**FINDINGS OF FACT
FLORENCE PLANNING COMMISSION
EXHIBIT "A"**

Meeting Date: December 12, 2023 **Planner:** Clare Kurth & Wendy FarleyCampbell
Application: PC 23 25 PUD 01: Myrtle Glen PUD

Proposal: A request to review and approve the Myrtle Glen final PUD application.

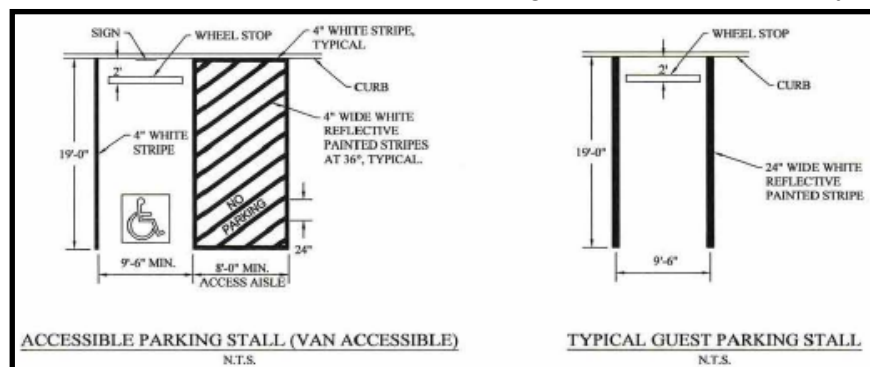
- 4.1 The shared/common parking area shall meet grading requirements so as not to drain stormwater over public ROWs. Parking lot surfacing shall not encroach upon public ROWs. This shall be in accordance with FCC 10-3-8-C. This shall be included on a detailed parking lot plan prior to or in conjunction with first building**

Attachment 1, Sheet C6 (Exhibit C) labeled *Overall Site Grading Plan and Cross Sections* illustrates the site will be graded to direct the flow of stormwater into the stormwater facilities and not over public ROWs. This plan does not indicate that any proposed parking lot surfacing will encroach on to public ROWs. This Condition is satisfied.

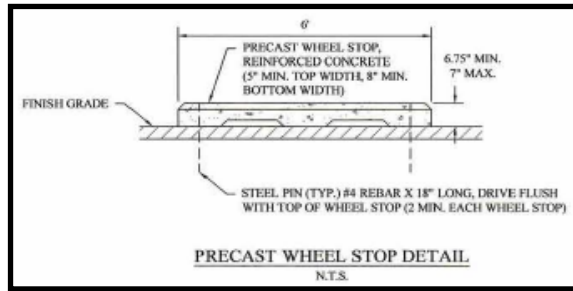
4.2 Parking spaces shall be screened with evergreen shrubs that reach a minimum 36 inches in height above parking lot grade level at maturity so that headlights do not shine onto adjacent residential uses and zones in accordance with FCC 10-3-8-D and FCC 10-34-3-7. Stormwater facility plantings in the 37th St ROW may meet this screening requirement or this requirement may be met through fencing installed between parking spaces and sidewalk/PUE. The screening plan shall be included in the final landscaping/stormwater facility planting with a proposed schedule of planting at final PUD.

Details of the planting areas abutting the parking area that will screen headlights from the parking lot are included on Attachment 3, Sheets L2 and L3 (Exhibit 3). These planting areas abutting the parking are proposed to be planted with Escallonia from 3 / 5-gallon containers. According to the [Tree and Plant List for the City of Florence](#) these plants reach a height and diameter of 5 feet, are evergreen plants, and are the recommended planting size. These plants meet and the landscaping plans for these areas are in compliance with FCC 10-3-8-D, FCC 10-34-3-7, and meet the requirements of this Condition. Note this five-foot screening area is located within a five-foot PUE easement and has multiple waste water and water service lines extending perpendicular through it. Any damage of the landscape buffer resulting from the repair or replacement of any utilities shall result in a replacement of the buffer by the HOA with the same species in 3 or 5-gallon containers. Effort should be made to preserve the buffer species for replanting prior to performing any work on the utilities. This Condition is satisfied.

Attachment 1, Sheet G1 (Exhibit C) indicated the minimum 5-foot rear yard setback for each individual lot in compliance with FCC 10-10-4-D. This Condition is satisfied.

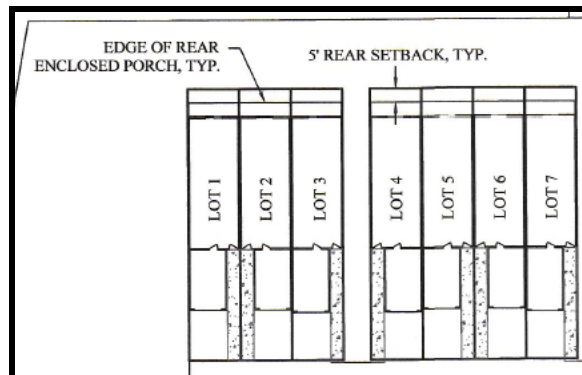
6.2 The applicant shall provide a minimum 5-foot rear yard setback for each individual lot in compliance with FCC 10-10-4-D.

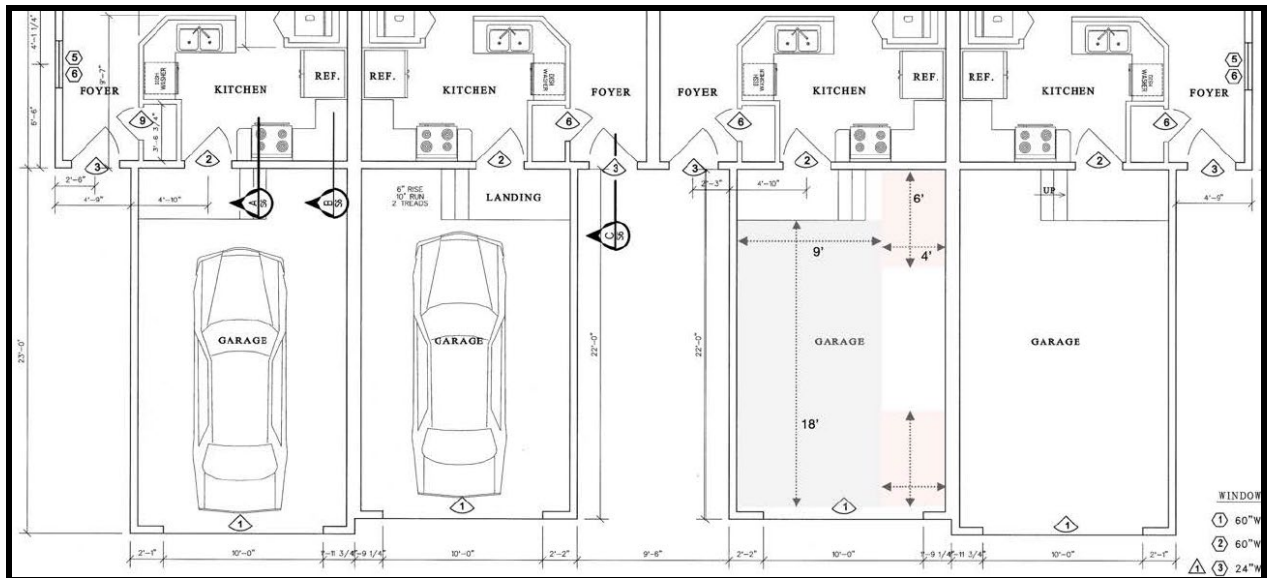
6.4 The applicant shall either provide long term bike parking that meets criteria in accordance with FCC 10-3-10-C or the applicant shall provide other long term bicycle parking onsite in accordance with FCC 10-3-10, this required long-term bicycle parking may either be located on individual sites or in common space. Long term bike parking will be verified prior to Certificate of Occupancy of each unit if provided on the individual lots, or with final PUD if provided in common or open space.

The applicant has provided sufficient evidence that there is adequate space within the interior of the garage to accommodate the parking of a standard sized car and the minimum clearance distance of 4 feet from the wall to the vehicle in accordance with FCC 10-3-10-C and this Condition. Please see the dimensioned image below from page 2 of Exhibit G. It further illustrates the available area from the 4-unit garage dimensions provided on Sheet S2 of Exhibit D-Attachment 2. The 3-unit garage dimensions are provided on Sheet S2 of Exhibit H-Attachment 5 and are a few inches narrower but meet the intent. This Condition is satisfied.

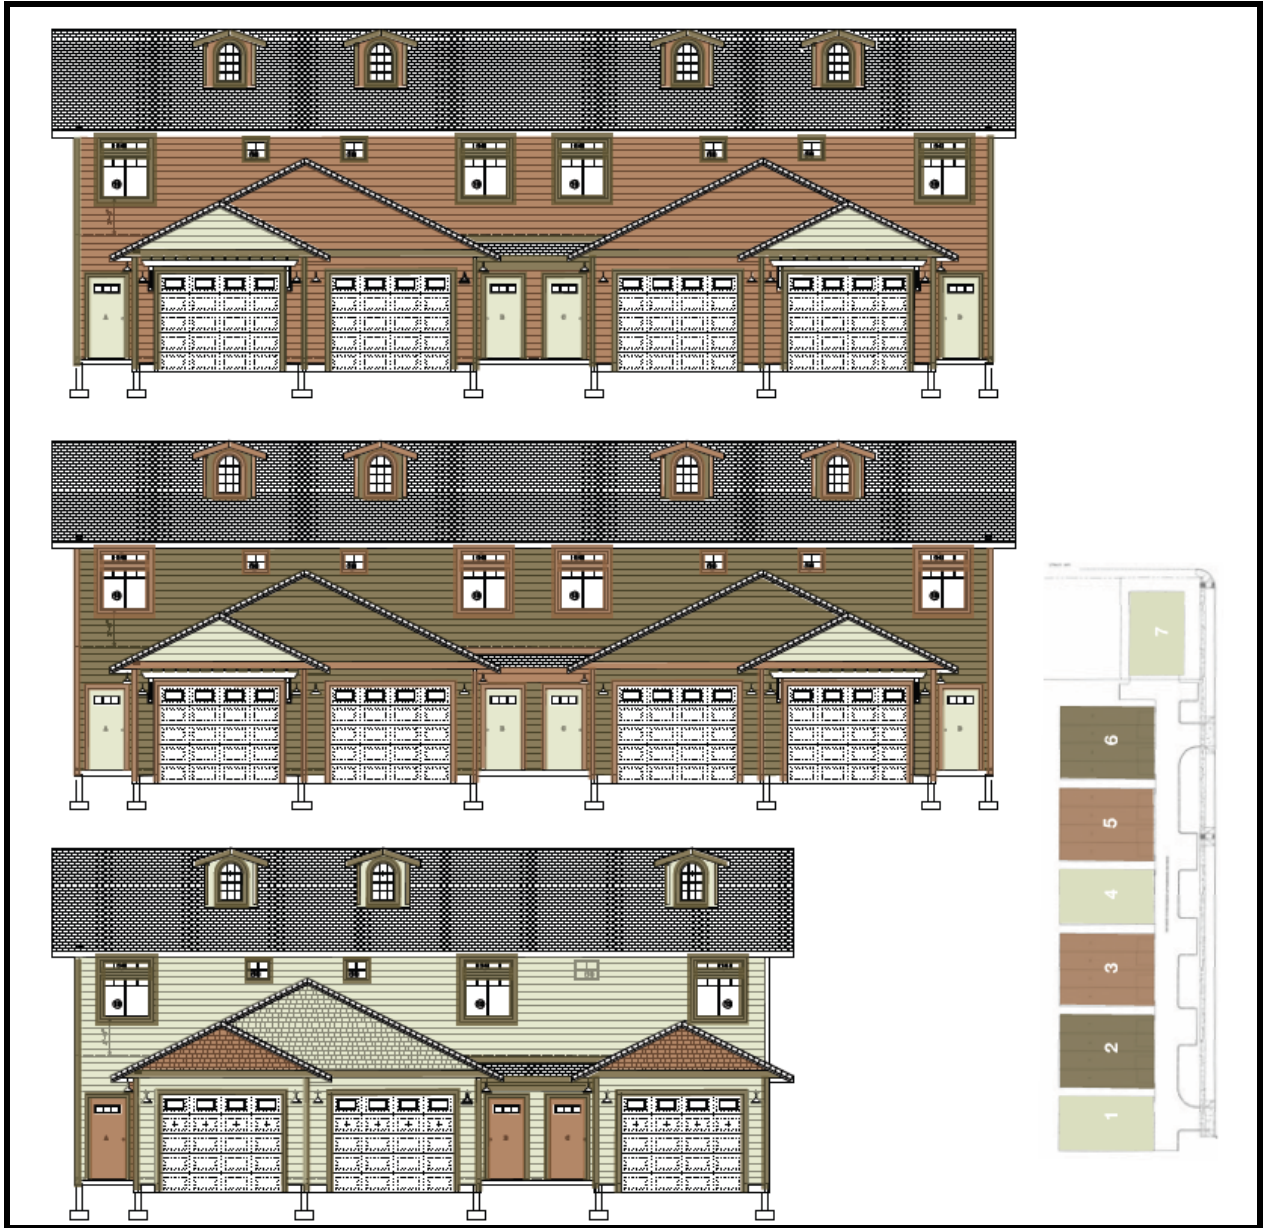
The proposed building designs include three color arrangements from a pallet of three colors-green, brown and tan. The three sets of three-unit buildings are proposed to have a base of tan paint while the four four-unit buildings are proposed to have green and brown bases (2 each). Each of the three-color arrangements alternate as seen in Attachment 6 (below) (Exhibit 1).

Façade changes are proposed as a variation in gable siding on the four-unit buildings (horizontal lap siding) and the three-unit buildings (shingle pattern siding). The shingle pattern siding shall be used on the four-unit building garage gables rather than the three-unit buildings to better break up the proposed long uninterrupted expanse (two sets of 150 ft.) of the same building style using horizontal lap siding (**Condition 2**). Please see the image below from Attachment 6:

- The applicant narrative explains in significant detail the difference in architectural details on the individual dwelling units rather than the required variation of each building grouping. This Condition specifies that there shall be different building facades and exterior designs for each building group that meets the intent of FCC 10-6-6. The variation on individual units does not meet the intent of requirement of this Condition

- The variation of garage gable siding patterns between the four-unit buildings and three-unit buildings, as the only architectural detail variation, does not meet the intent of this Condition or this Condition as written.

4. The only architectural change between each type of building grouping is the gable siding being a shingle pattern on the three-unit buildings and horizontal lap siding on the four-unit buildings.
 - As previously Conditioned, the shingle pattern siding shall be used on the four-unit buildings rather than three-unit buildings to better break up long expanses of horizontal siding.
 - The variation in garage gable siding of shingle pattern and horizontal pattern does count towards one variation in façade for the building groupings.

Below is a snip from Attachment 3, Sheet L1 (Exhibit E).

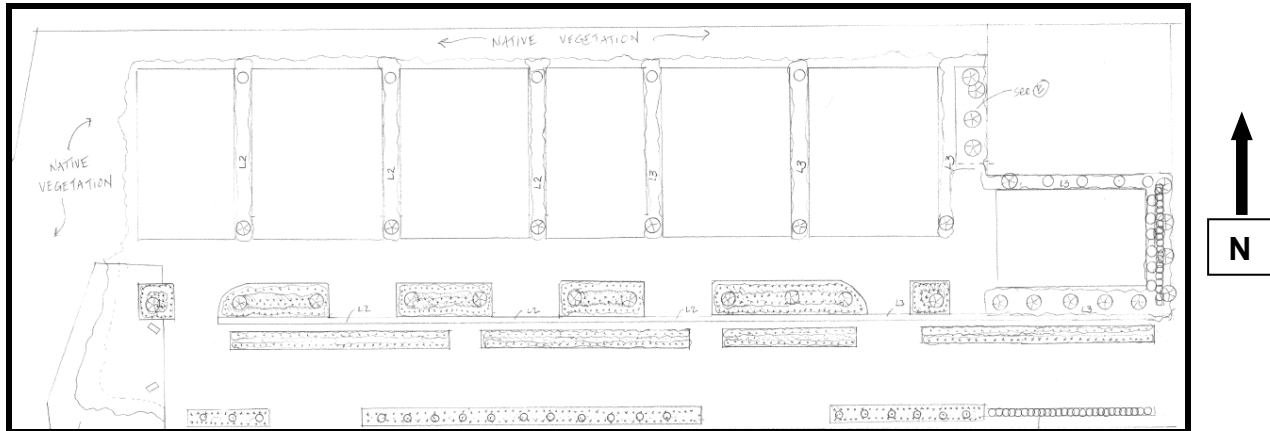
Northern Buffer: Landscaping and vegetation retention plans have been submitted as part of this application as required by this Condition. The applicant has included a statement on page 6 of 8 in the response to the NOIC (Exhibit G) that states “Attachment 3 Landscaping Plan satisfies this condition. As depicted on the plans and explained in the application narrative: the northern vegetative buffer is proposed to remain in place. This buffer area is approximately 5 feet deep, 650 feet long, and densely vegetated. Given all trees and shrubs are proposed to remain within this buffer, trees and shrubs will be retained at a ratio of at least one tree per 30 feet.”

Native vegetation buffer has not been inventoried to confirm that trees on this northern buffer meet the minimum 1 tree per 30 linear feet, or a minimum of 22 trees retained along the northern buffer ($650/30=21.6$ – rounded up 22 trees are required to be retained). It is anticipated that the minimum number of required trees will be retained based on the applicant statements. However, the applicant shall submit an inventory of trees to satisfy this condition. In accordance with FCC 10-34-3-8, any required trees on the northern buffer that dies, falls, or is damaged during construction or at any time after development shall be replaced with an equivalent specimen within 6 months of dying or removal, whichever comes first (**Condition 3**).

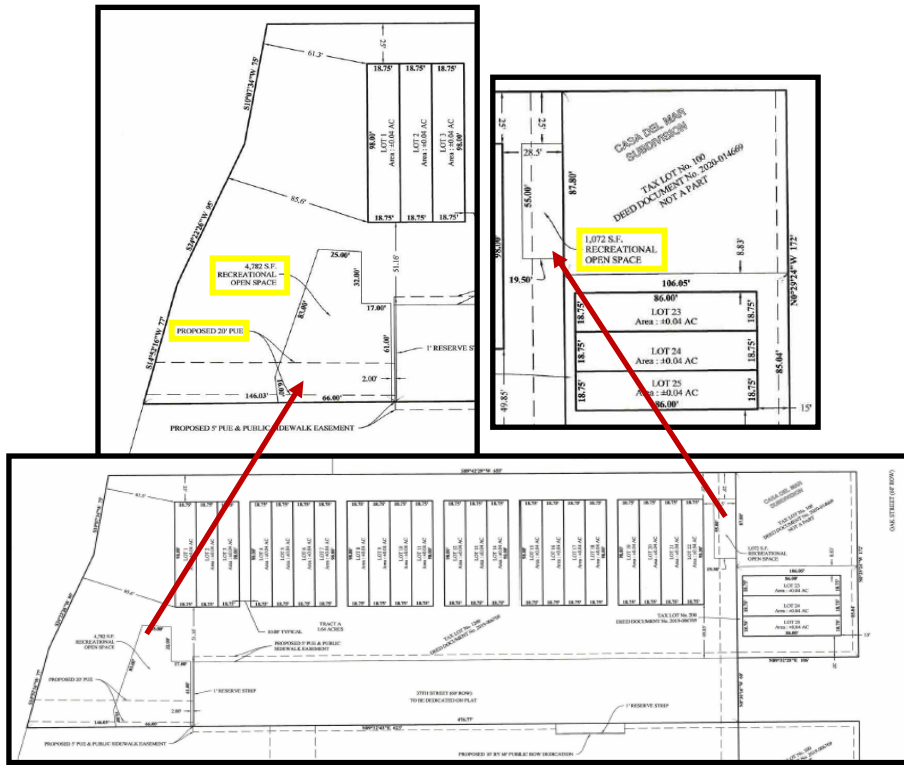
Discussion on Additional Open Space Concerns and Considerations: Below is an explanation of the proposed open space as it relates to proposed improvements, amenities and long-range concerns for preserving the proposed open space with future development.

According to FCC 10-23-5-G, areas that are not acceptable for recreation area required as part of a PUD include easements. The intent of this statement was to ensure open space and recreation areas were developed to meet their intended use. There is a 20-foot public utility easement on the south portion of proposed Open Space A as seen in Attachment 1, Sheet G5 (Exhibit C). A snip of this area is included next:

A snip of the open space locations shown on the plat is included above. The easement and the location of the easement do not adversely affect the use of the proposed open space for recreational purposes. Therefore, while an easement is present in the open space it is determined that this open space as proposed can meet the open space requirement for minimum square footage as required in FCC 10-23-5.

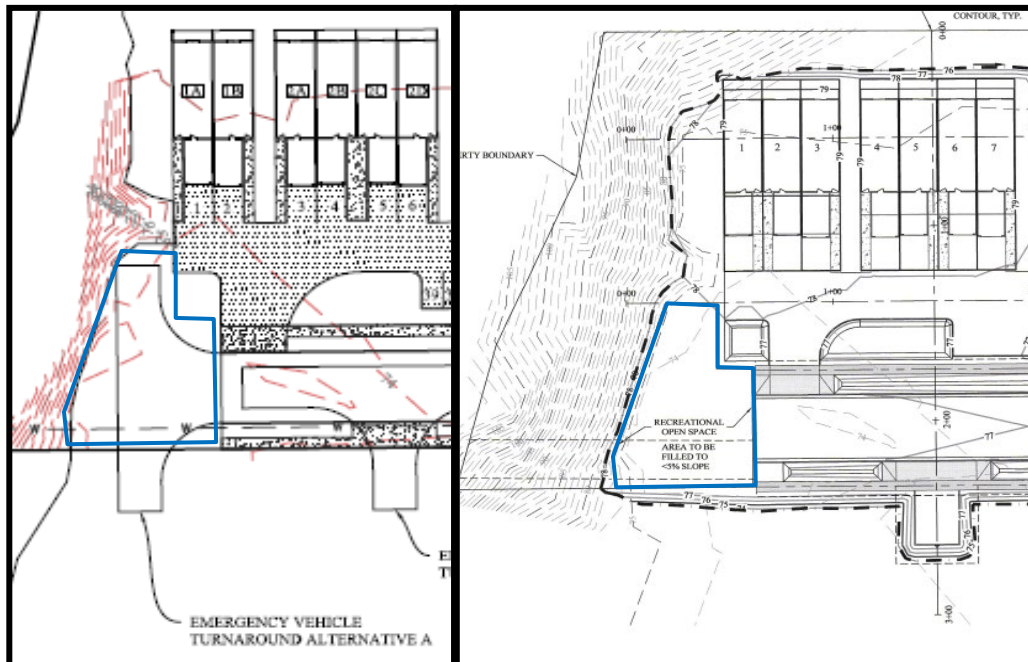
During the June 22, 2023 hearing an image of an alternative turnaround was shown to the Planning Commission with an applicant explanation that 37th Street may be developed and connect to 35th Street to the south. This is significant as extending 37th Street west would eliminate the majority of Open Space A, which is approximately 82% of the recreation Open Space on site.

$$4782 \text{ (Open Space A)} / 5834 \text{ (Required Recreational Open Space)} = 0.819 \text{ or } 82\%$$

Therefore, future development of 37th Street to the west would eliminate the majority of the required recreational open space as proposed and will require additional recreational open space to be developed at a later date, or the applicant may pay a fee-in-lieu for the required recreational open space for a park to be developed on the lot to the south at a future date and dedicated to the public.

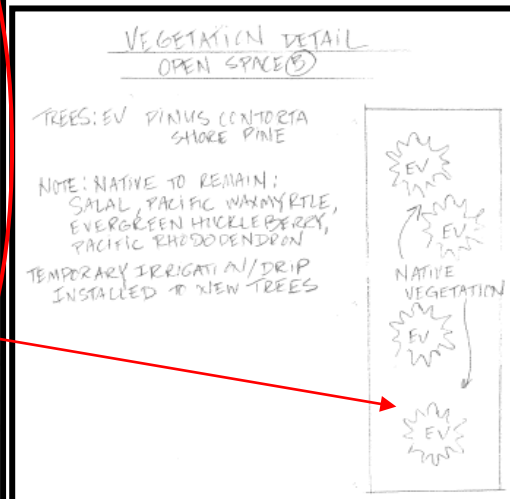
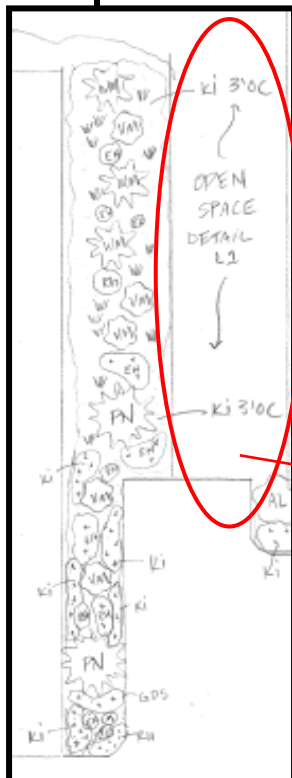
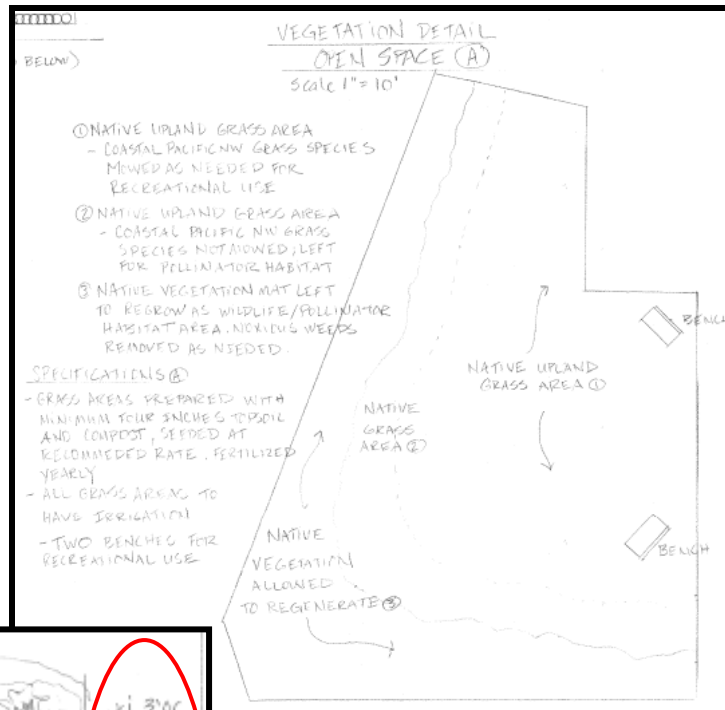
Sufficient evidence has not been submitted in the tentative concept plan that the recreation open space is supporting both active and passive recreation. Below are snips of the two open space areas proposed.

Open Space A: Improved with grass and two benches. No details provided regarding bench design or quality. No information provided regarding recreation need this area is intended to be improved for.

Open Space B: Area is proposed to be planted with new shore pines and existing native vegetation. The area to the west is also landscaped. While the landscaping meets landscaping requirements this also serves as a barrier to access the intended recreation open space B. No intended use is identified for this area. The improvement proposed to this area is the planting of 4 shore pines. Additional amenities are required for this area to be improved to an intended recreational need. In accordance with FCC 10-23-5-G, recreational open space is required to be developed for its intended use and the recreational open space shall meet the needs identified in the [Florence Parks and Recreation Master Plan](#).

The driveway widths are included on Attachment 1, Sheet C9. These driveway widths are dimensioned at 24 feet in width each. This Condition has been satisfied.

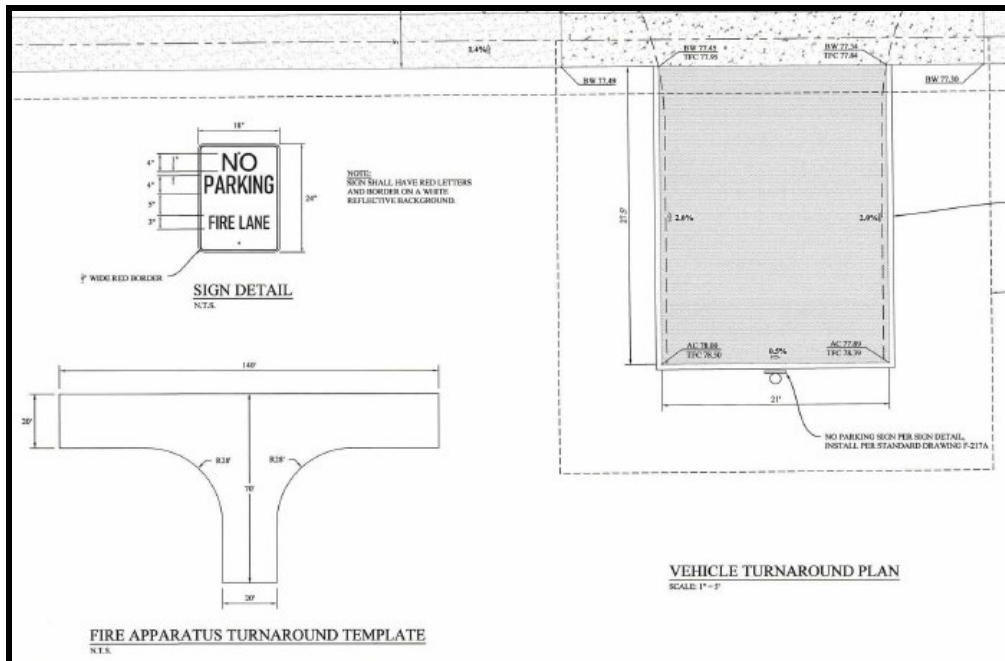
8.2 The maximum driveway width allowable under FCC 10-35-2-12-B for driveways serving single-family residences shall not be more than 24 feet shall be a minimum of 18 feet where the driveway provides two-way traffic. Therefore, the two driveway access points proposed on 37th St shall be a maximum of 24 feet in width and a minimum of 18 feet.

Below are snips from Attachment 3, Sheet L1 from the landscaping plan (Exhibit E). The top image is of the vegetated swale on the north side of 37th Street at the 37th and Oak Street intersection and the bottom image is of the planting area on the south side of the 37th and Oak

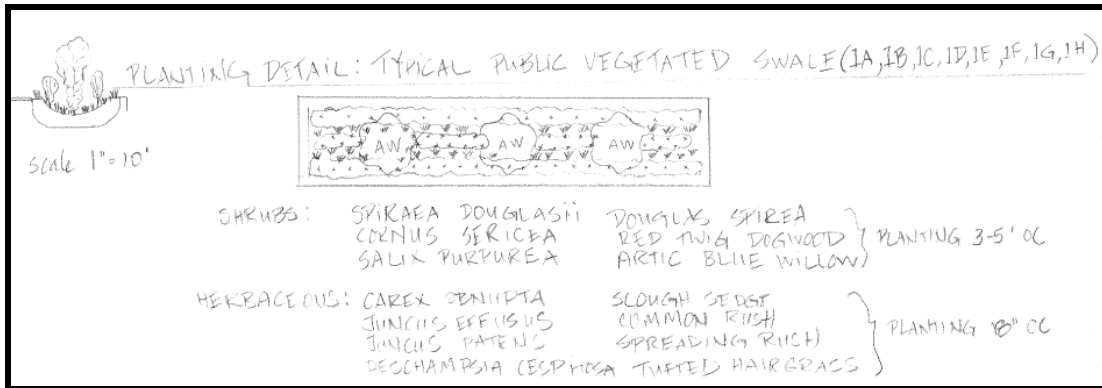
8.6 Vision clearance at 37th and Oak Street shall be confirmed during building inspection or by staff site visit prior to final approval to ensure compliance with minimum vision clearance.

Street intersection. These proposed planting areas use plantings that are not anticipated to interfere with vision clearance. This shall be confirmed during final building inspection as stated in this Condition.
